# **Coordinator-General's evaluation report for an environmental impact statement**

## **Northern Pipeline Interconnector – Stage 2 Project**

**November 2009**

# Northern Pipeline Interconnector – Stage 2 Project

**Figure 5 Three alternative route alignments in proximity to Yandina township**

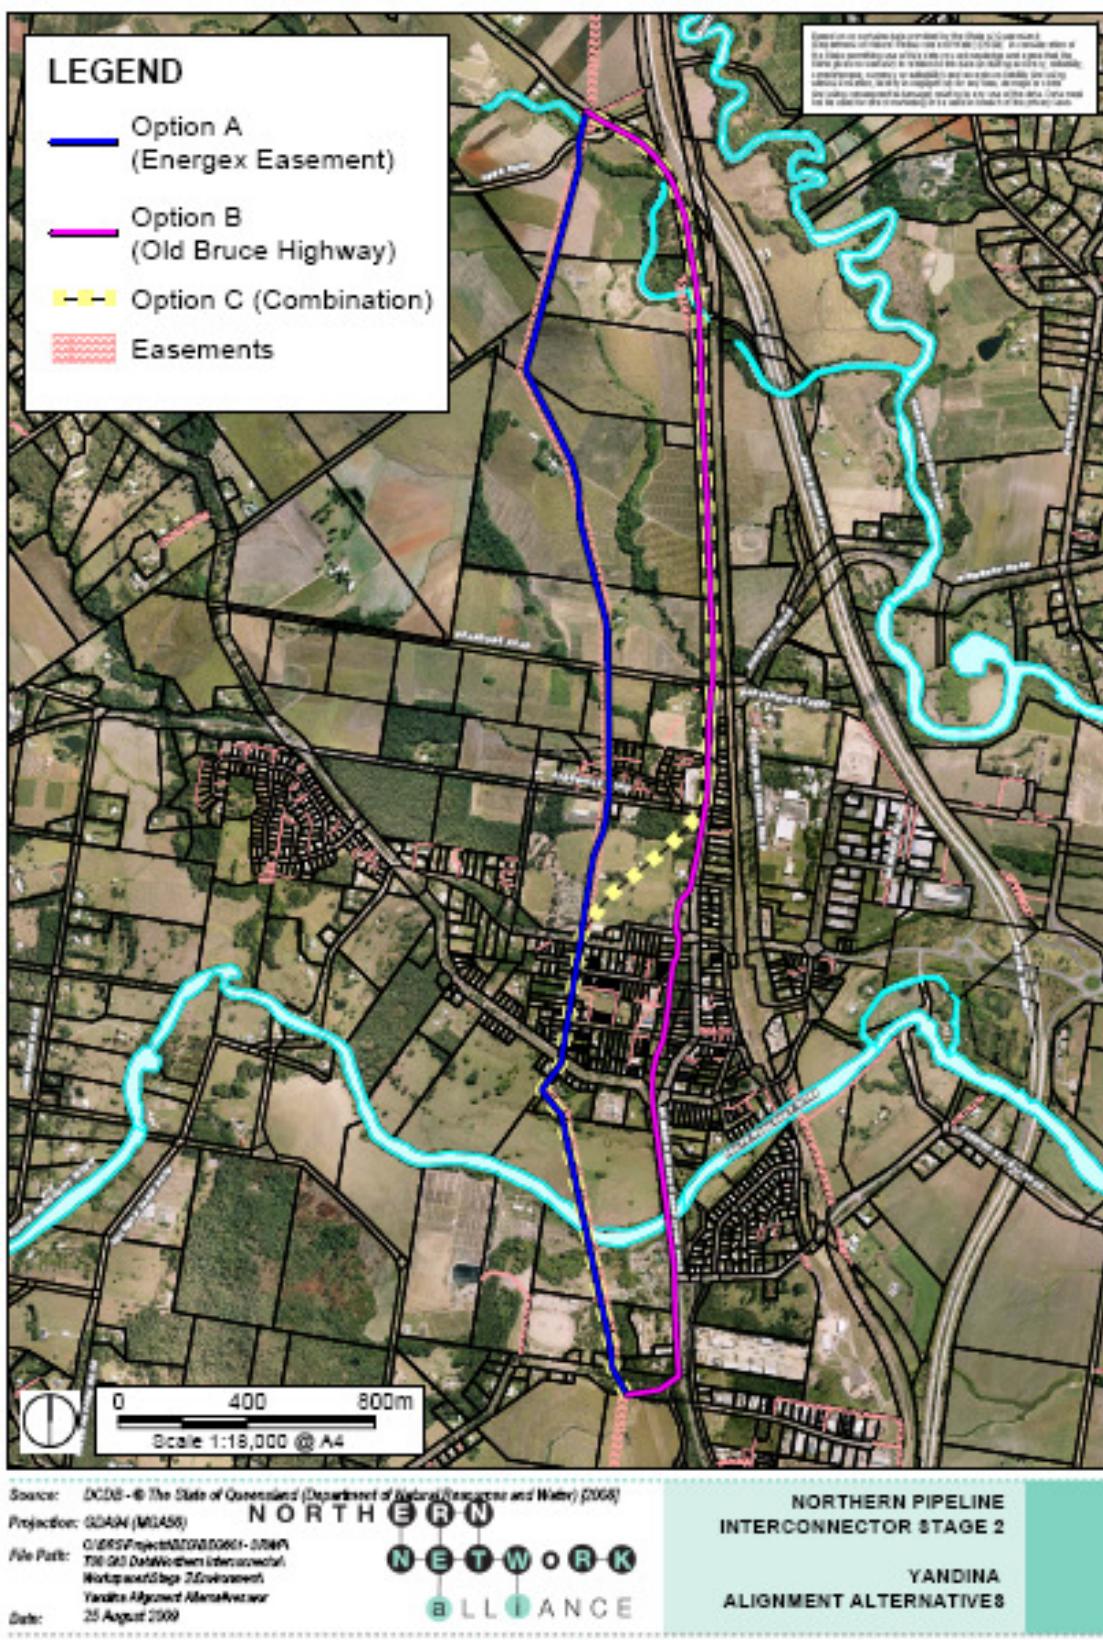
Three alternative route alignments, see Figure 5, were considered through and in proximity to the Yandina township:

The preferred corridor in proximity to Yandina was chosen by LinkWater Projects following a multi-criteria analysis including the assessment of construction timeframes, environmental and community impacts. LinkWater Projects has suggested that the preferred corridor presented a number of benefits including:

**Figure 6     Robinson Road Alternate Route Option**

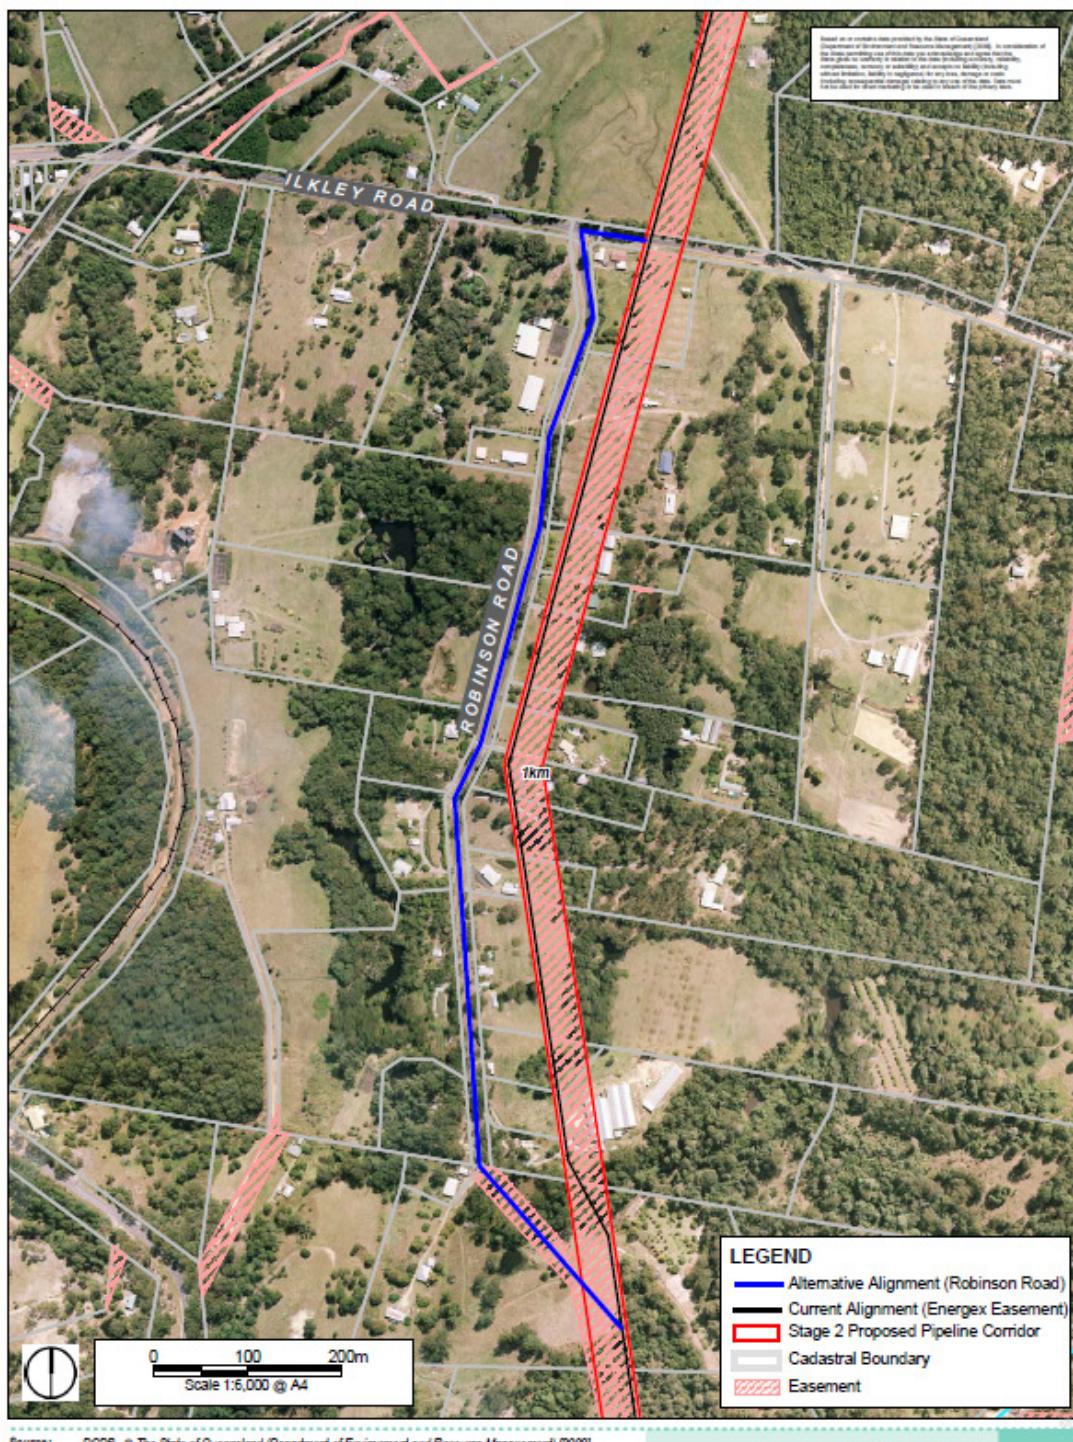
A further submission received on the EIS suggested an alternate route for a section of the pipeline of following the Robinson Road reserve rather than the Energex easement. Figure 6: Robinson Road Alternate Route Option shows the proposed route.

The SEIS further states that to construct the pipeline along Robinson Road one lane would need to be closed, with the other lane remaining open for access to the properties along the road. This would result in a longer construction period through this area and greater impacts on the residents along both sides of Robinson Road.

Based on the information provided in the SEIS and submission received, I am of the view that the route proposed by LinkWater Projects has less community impacts and construction costs, with reduced environmental impacts due to being largely located in an existing utility easement.

## Figure 10 Ferntree Facility Area

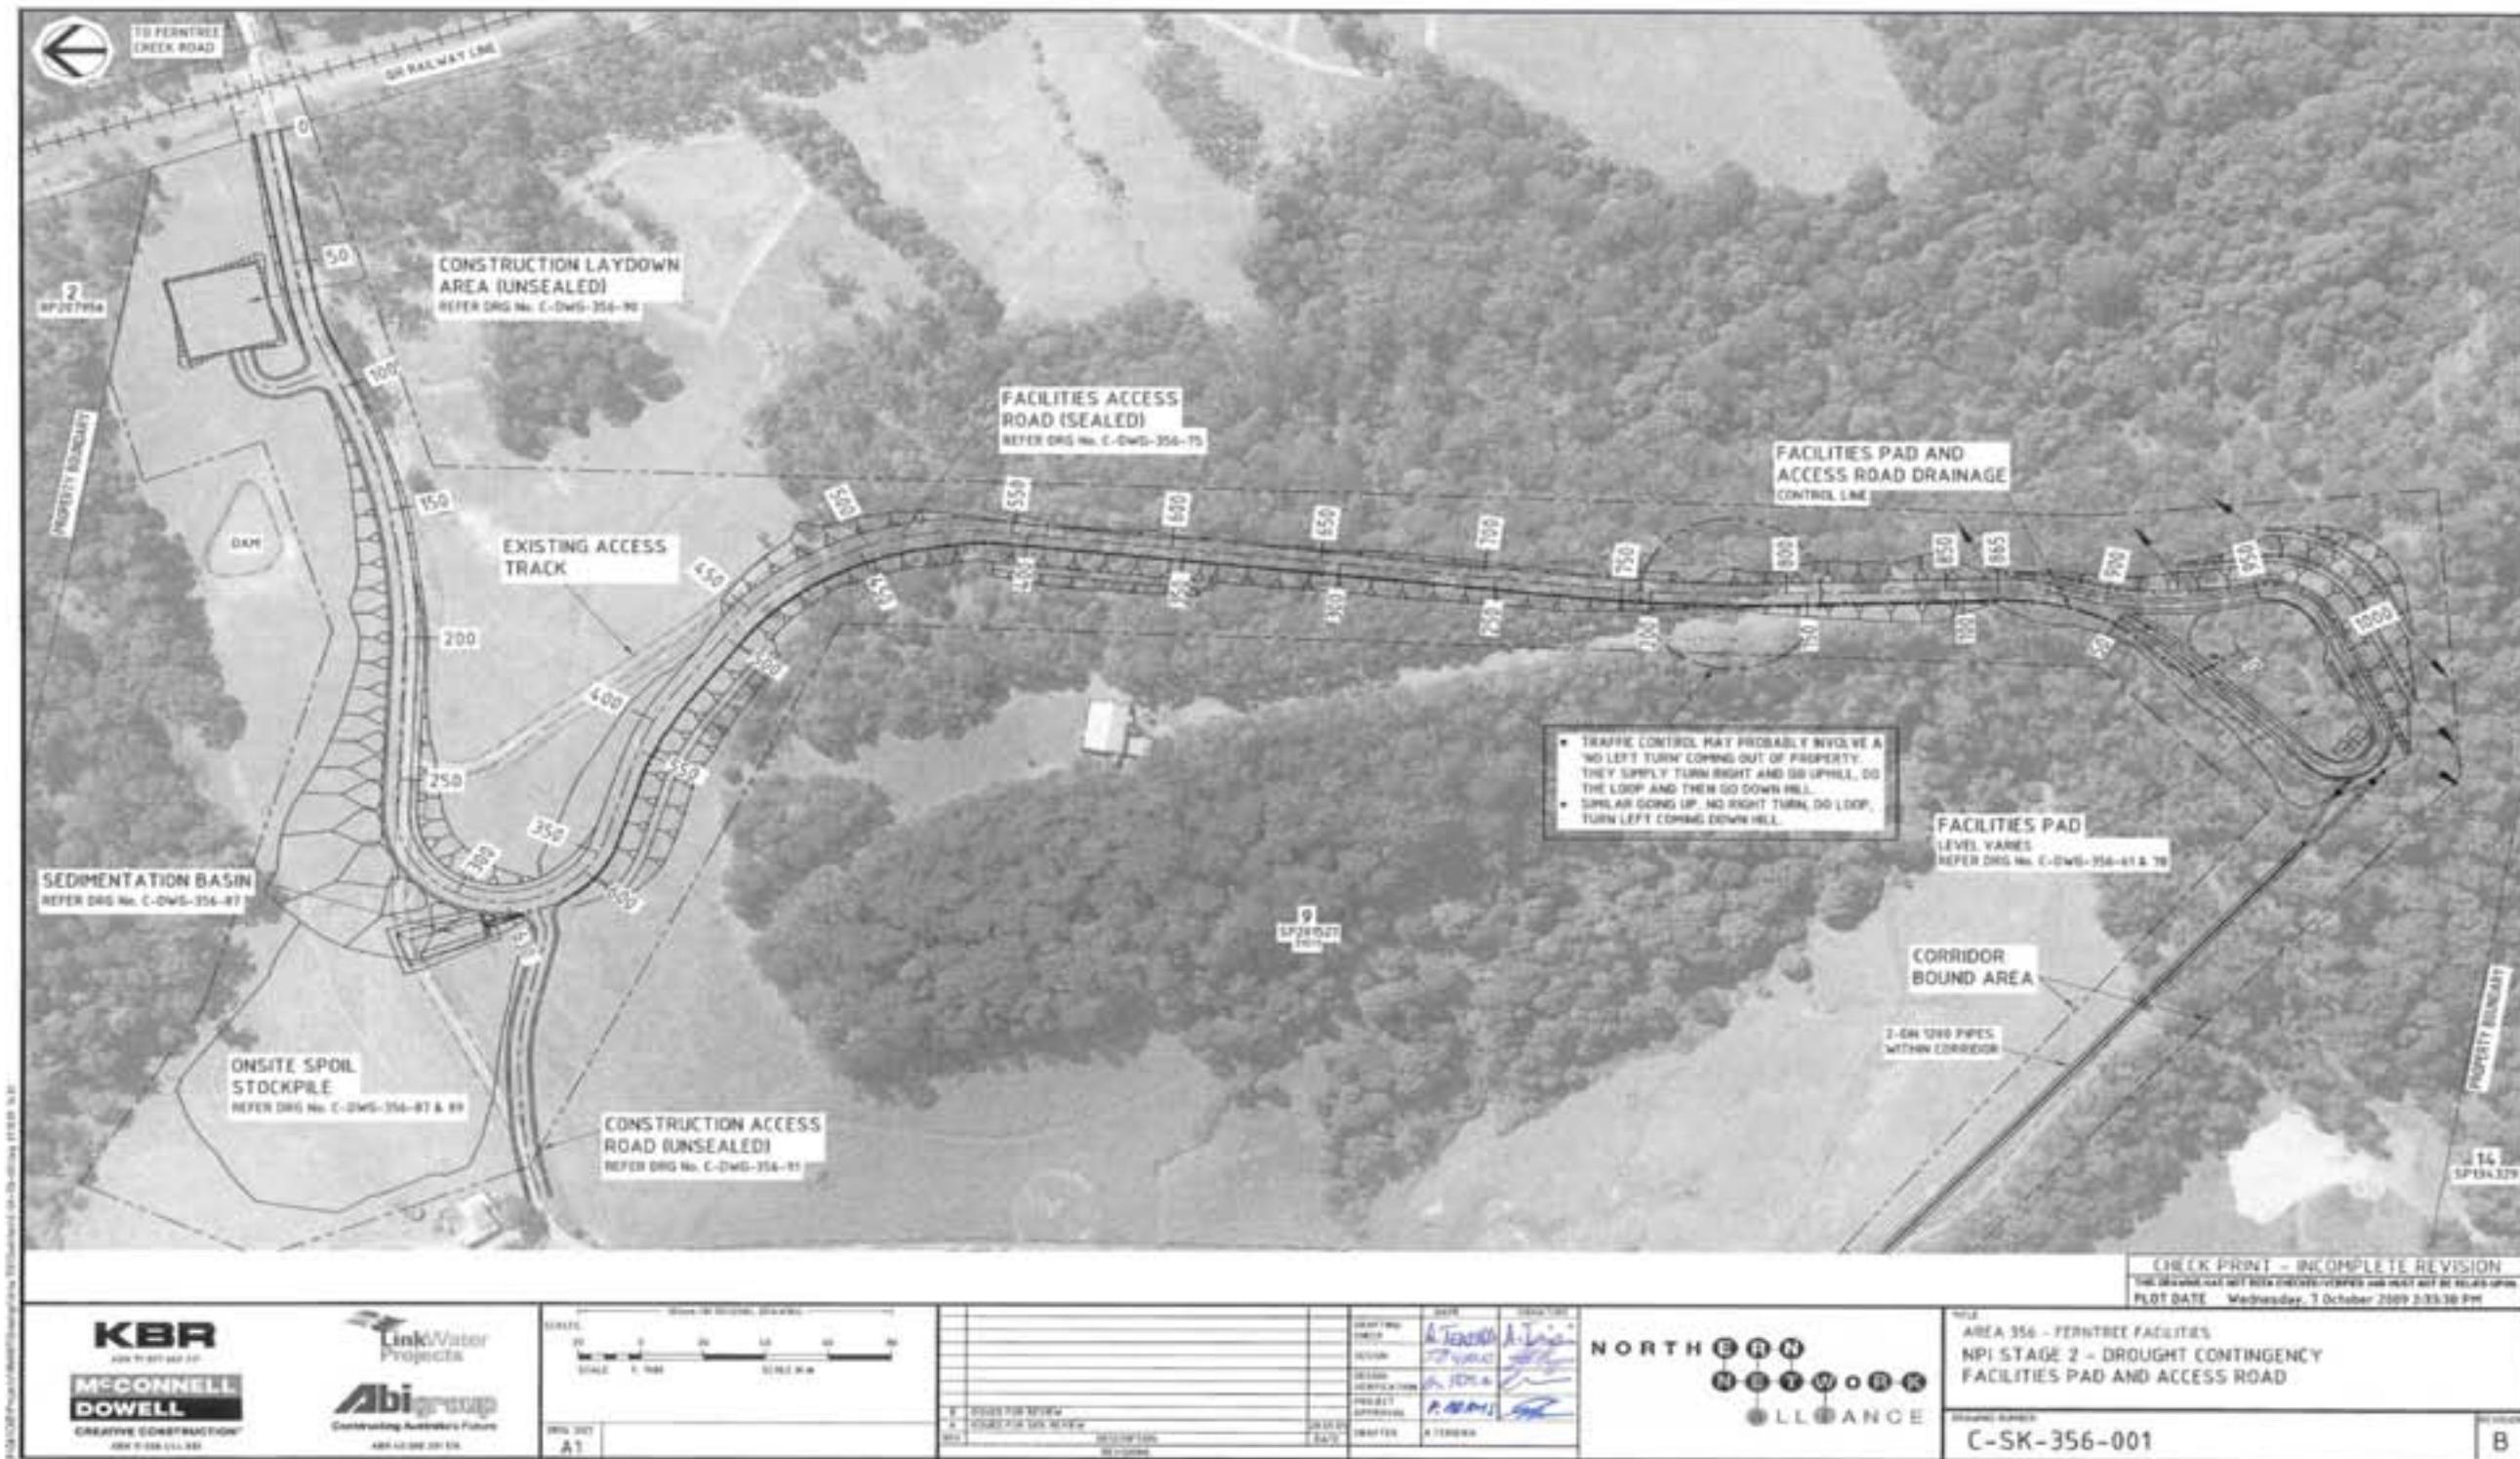
Since the release of the SEIS, LinkWater Projects has further refined the access track to the facility proposed at the FFA and the layout of the facilities. This is shown on Figure 10 – Ferntree facility area. The refined access track and facility layout will reduce the clearing impacts and disturbance of the wildlife corridor.

**The location of the Ferntree Facilities Area (FFA) facilities are to be constructed in accordance with Figure 10 Ferntree Facility Area. Any variation to the layout is to be approved by DIP.**

The location of the FFA facilities are to be constructed in accordance with Figure 10 Fertree Facility Area. Any variation to the layout is to be approved by DIP.

Figure 15 Aerial photo of the route options at McGilchrist Road and Chevallum—Palmwoods Road

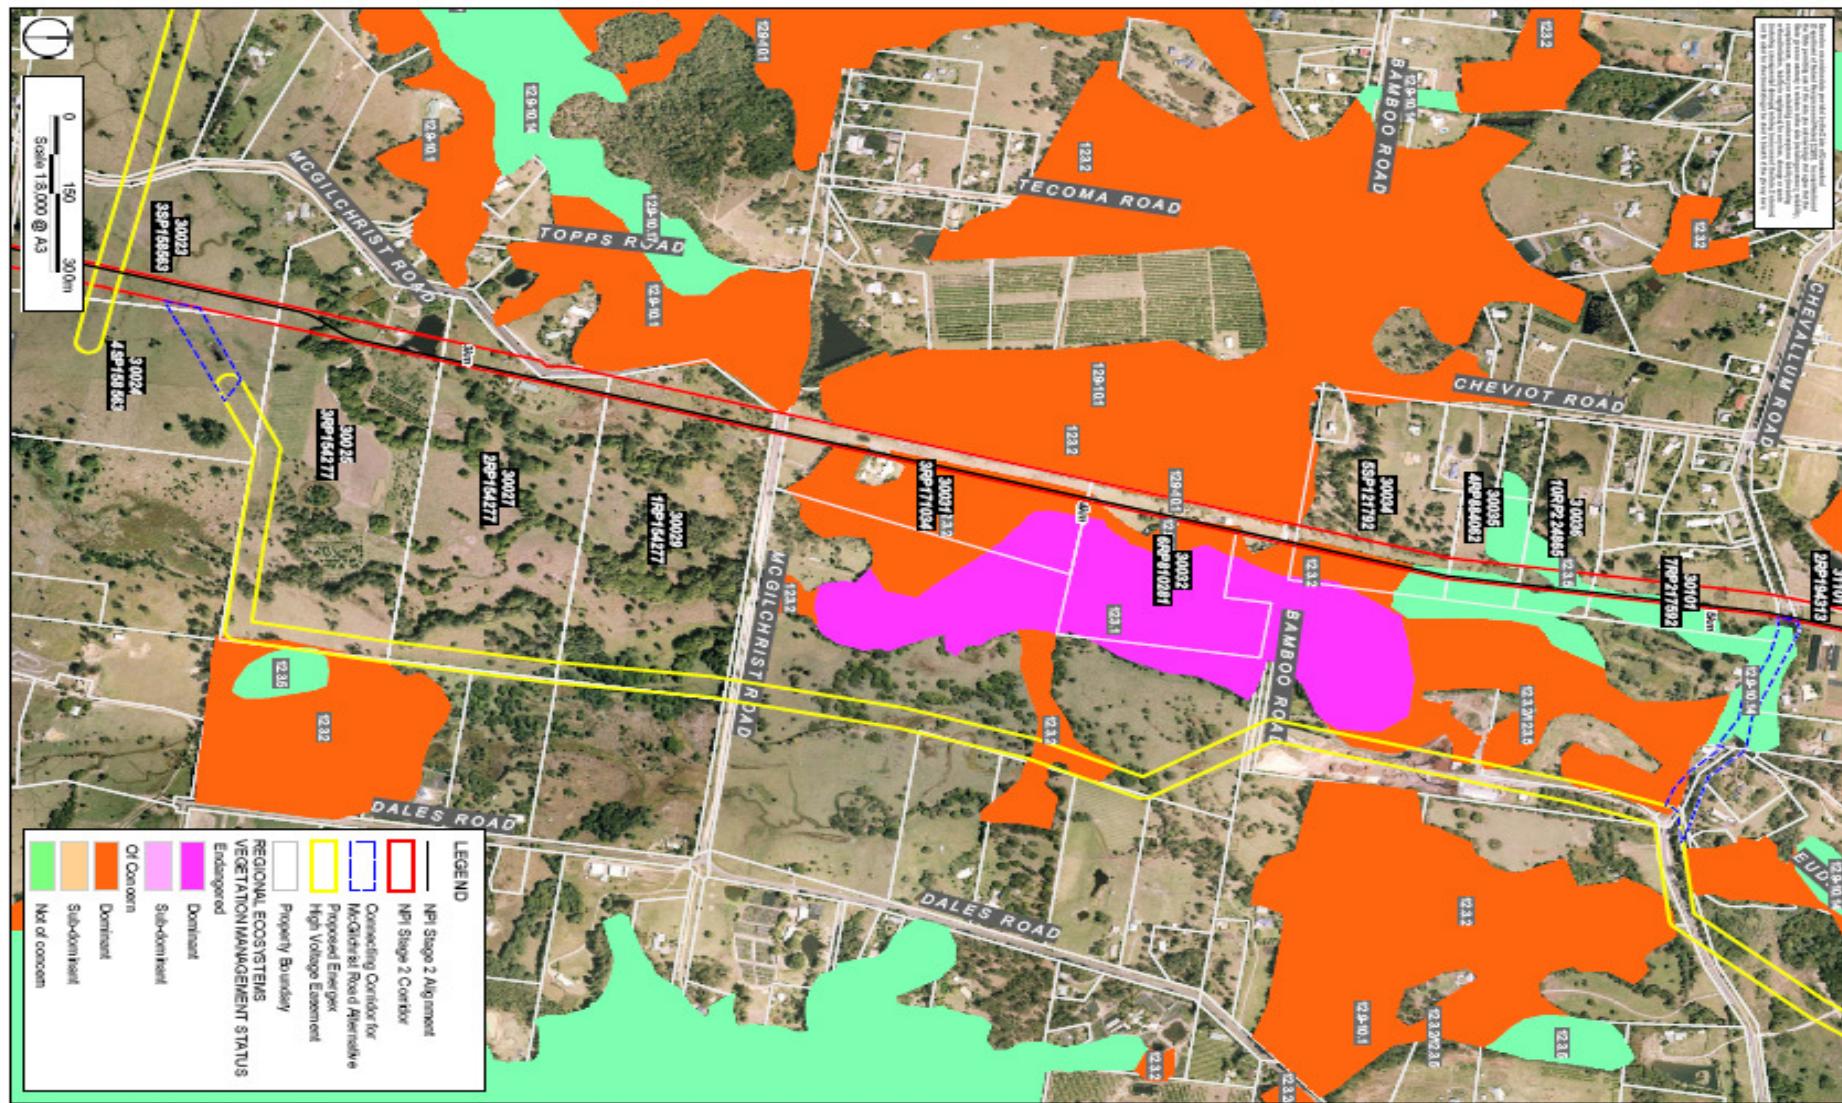
At the inspection representatives of LinkWater Projects advised that, for safety reasons, the full width of the corridor would be cleared. LinkWater Projects was given the opportunity to justify this need in the SEIS, but this information was not provided. This has highlighted an issue of unnecessary corridor clearing. LinkWater Projects has asserted in response to the private submission that the preferred corridor is located within an existing easement, and will not require clearing of intact remnant vegetation. DIP requested from LinkWater Projects an aerial photo of the route options at McGilchrist Road and Chevallum — Palmwoods Road which showed the vegetation management status. This map is provided as Figure 15.
